COMMENTS ON PROPOSED REACTOR SITE CRITERIA

The following comments on the reactor site criteria, Staff Paper AEC-R 2/19, are based on NRTS operational experience and field studies on uncontained research and test reactors.

Enclosure:
Sample isopleth

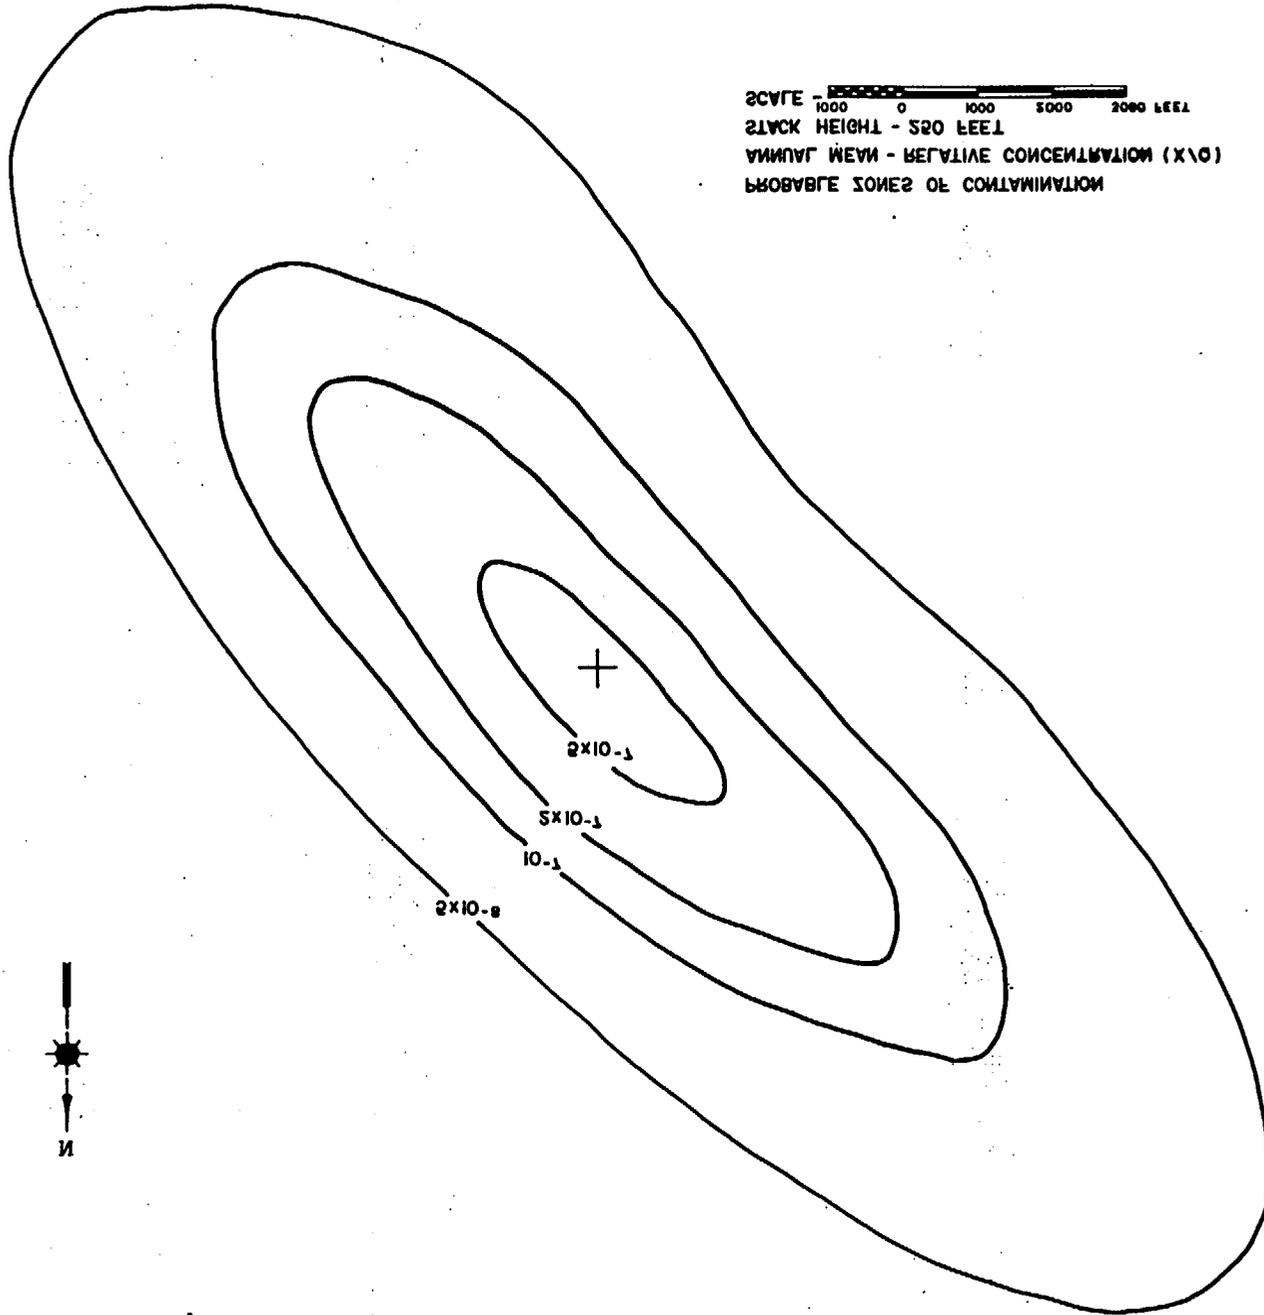
Circular exclusion and evacuation areas of certain radii can be questioned based upon observed and computed air concentration and deposition patterns. This is particularly true for regions where winds usually blow along certain directions, such as valley-mountain winds confined along the valley axis, or channelled winds along river valleys. This is even more striking if winds of one direction are associated primarily with temperature lapse conditions, and winds of the opposite direction are associated with inversions. Long period integrated air concentration or deposition isopleths, as well as computed mean diffusion isopleths of relative concentration, are more elliptically shaped along the prevailing wind direction. Therefore, elliptically shaped exclusion or evacuation areas are preferable to circular areas. Enclosed is a sample isopleth for the southern part of the BRTR to demonstrate this approach.
